SADDLEHORN RANCH -
FILING 2
STREET IMPROVEMENT PLAN
AND PROFILE

SHEET 14 OF 40
JOB NO. 25142.04

**CL- EL RAICENO PLACE PROFILE
STA 100+00.00 TO 108+00.00**

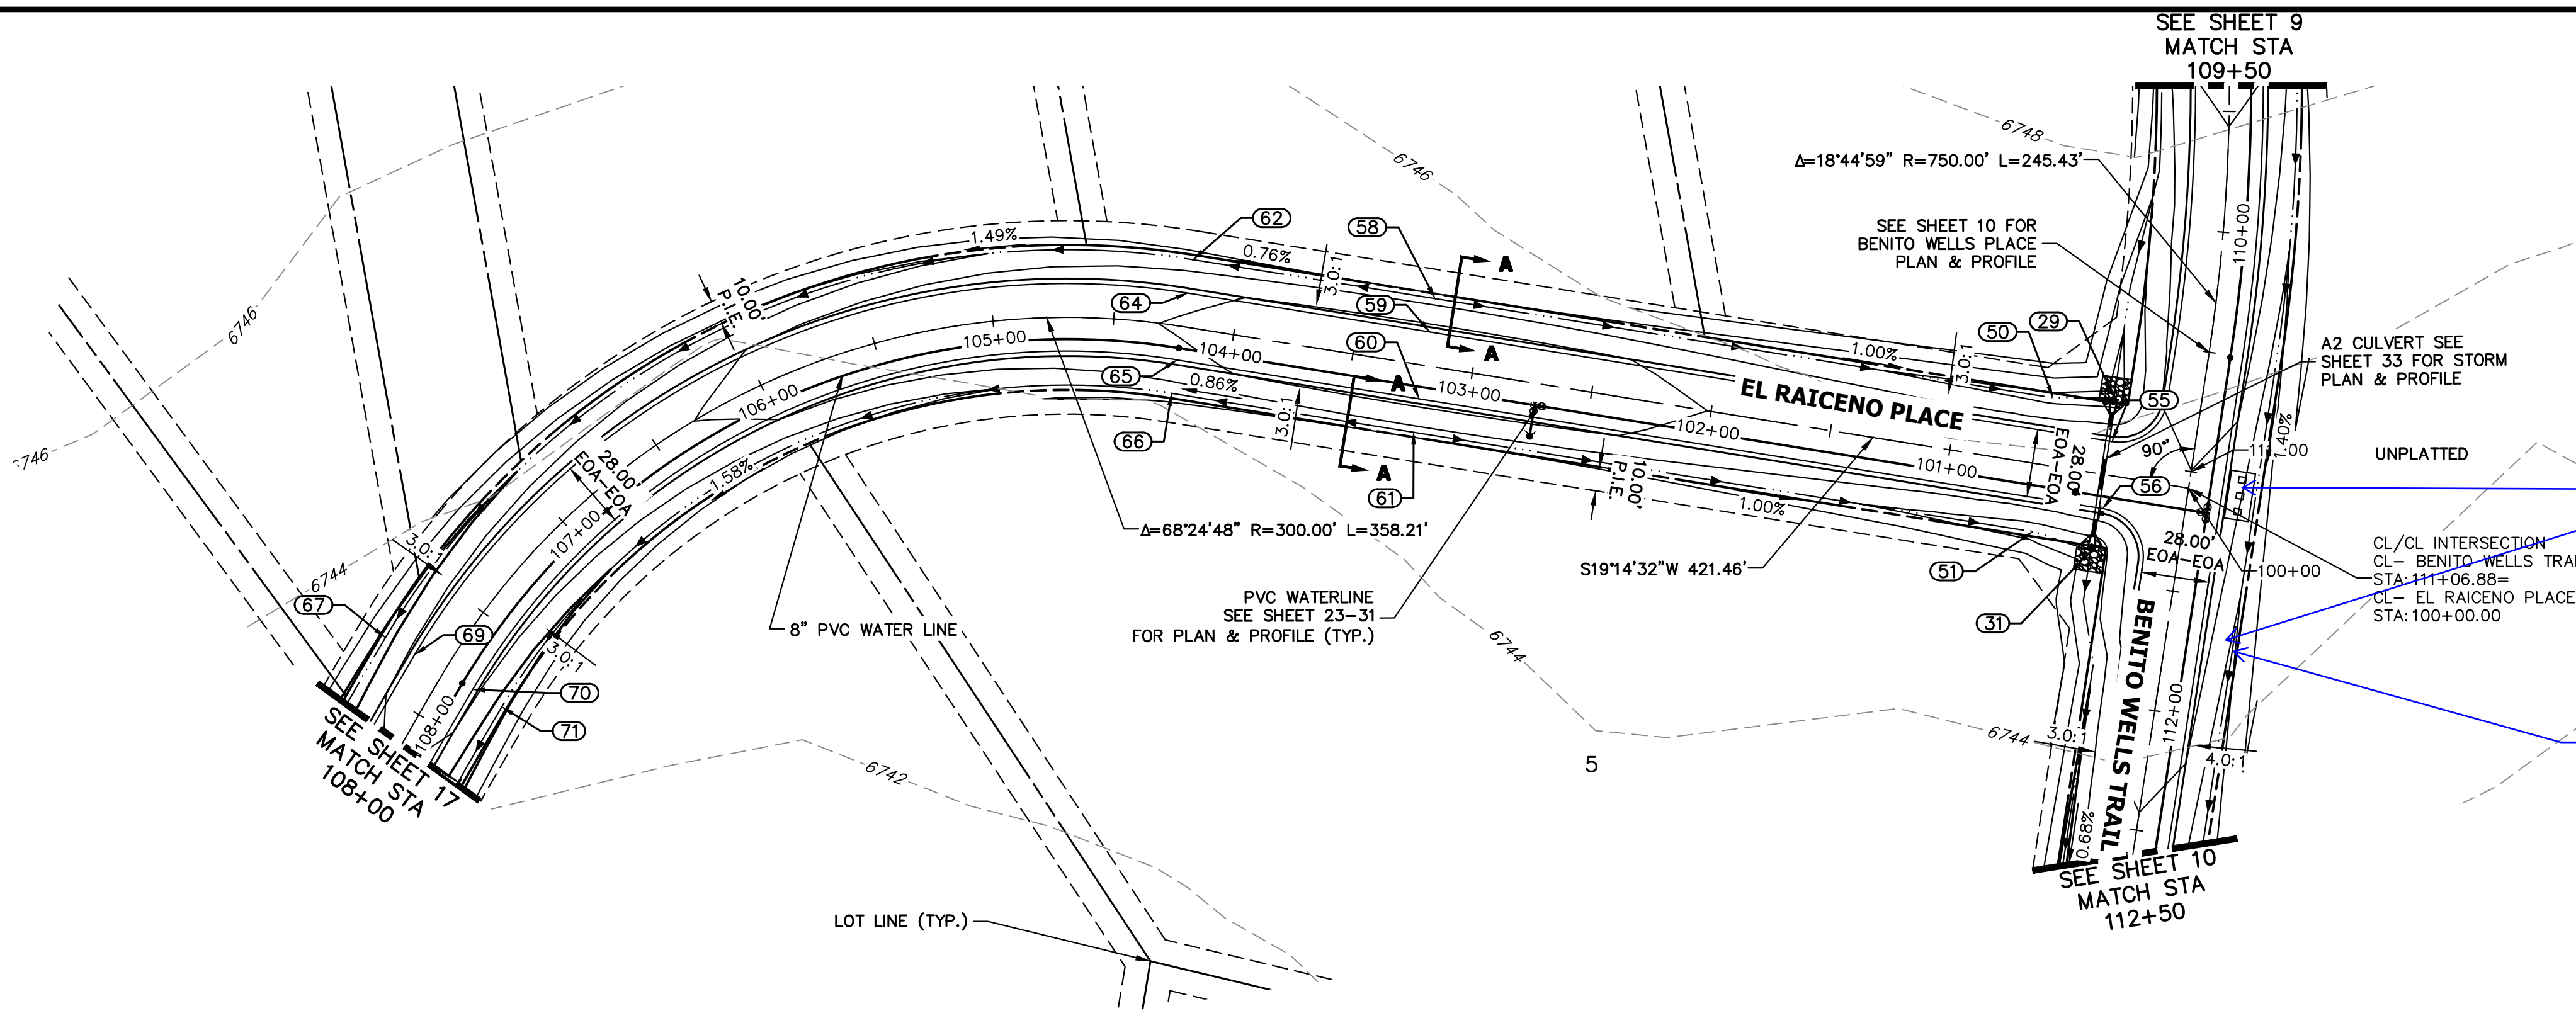
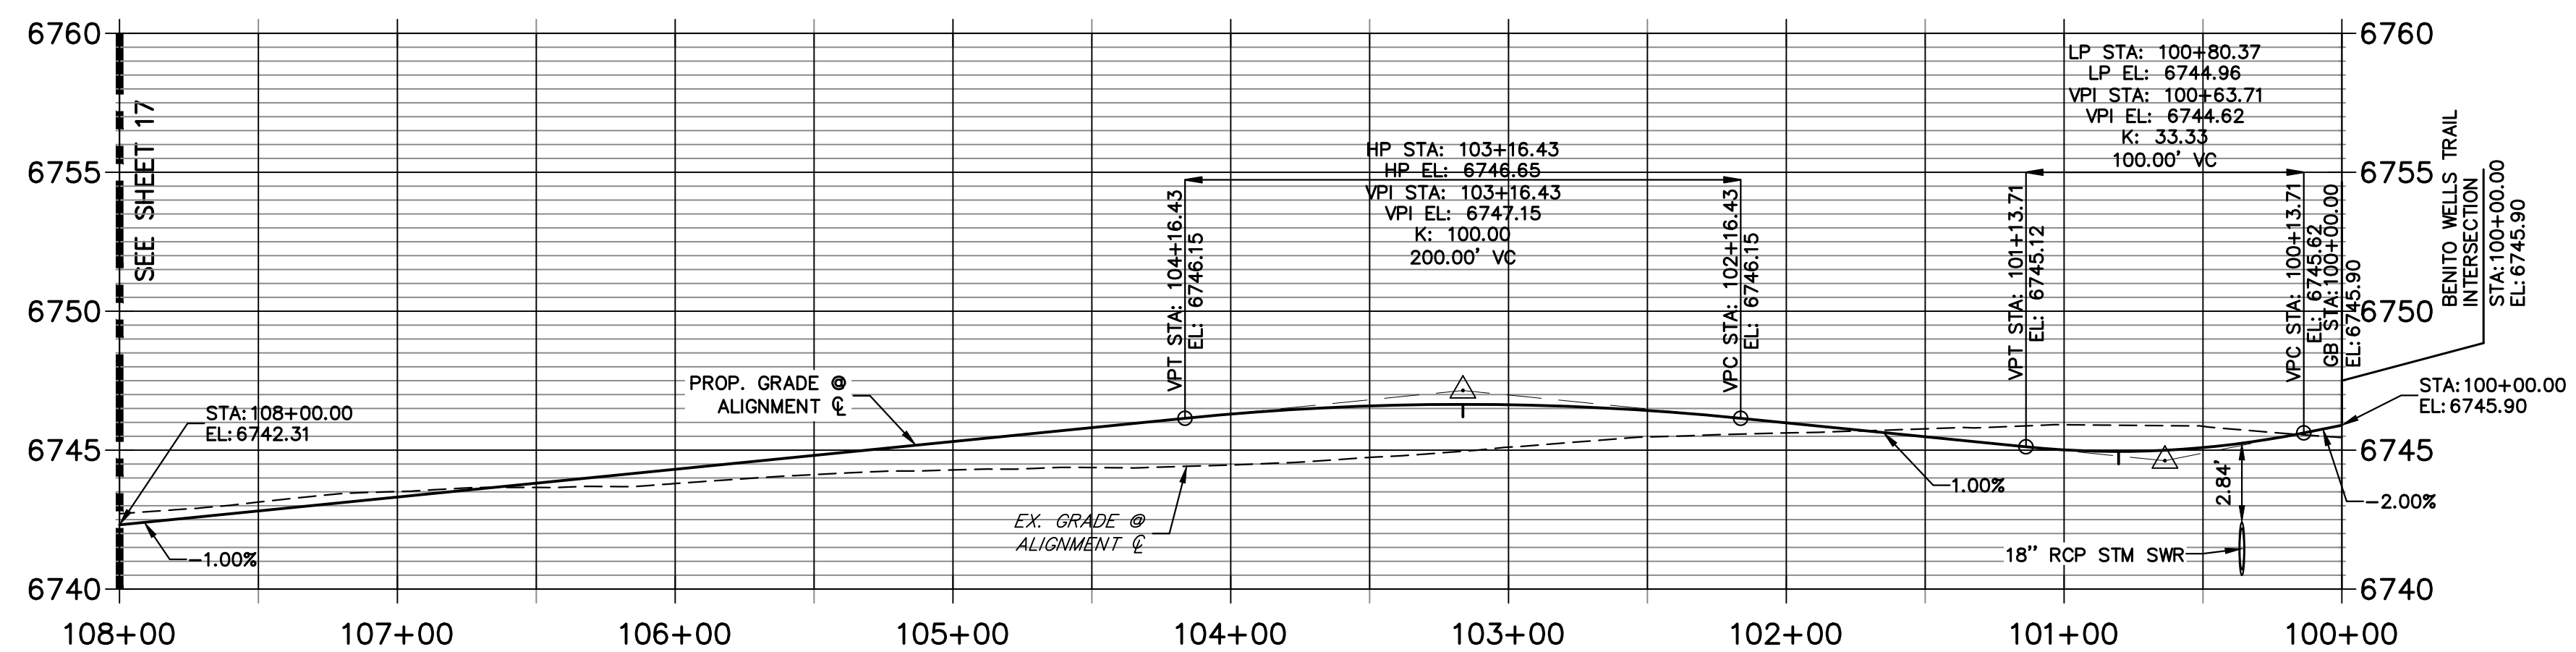
Mail kiosk should be east of the intersection

Revise ditch to go around the kiosk. Update ROW and easements as needed.
